PLANNING, ZONING, & BUILDING DEPARTMENT
PZ&B Staff Combination Memorandum: Architectural Commission and Town Council

SUBJECT: ZON-23-043 (ARC-23-044) 1480 N OCEAN BLVD

MEETING: MAY 29, 2024 ARCOM
JUNE 12, 2024 TC

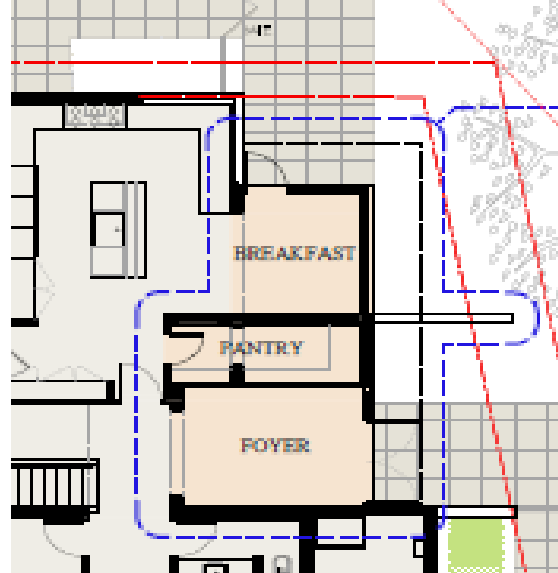
The existing layout and design of the home is unique to other single-family residences in the area. Designed in a modern architectural style, with white geometric forms and planes, the front entry has an accent wall that projects to reveal the front door and bisects it from a one-story glass geometric atrium interior dining space. The property has matured landscape hedges on the east and south. The area of work is not visible from the public right-of-way or adjacent neighbors.

Architecturally, the proposed changes simplify and coordinate that portion of the façade and remove a dated glass atrium element.

The structure is an existing nonconforming structure as it pertains to the cubic content ratio (CCR). The expansion of the covered entry area increases this nonconformity of CCR to 5.12. However, it is important to note that the actual expansion is just 107 SF of an covered areas and increased footprint. The lot coverage conversely is well under the maximum allowance of two-story structures by nearly 700 SF.
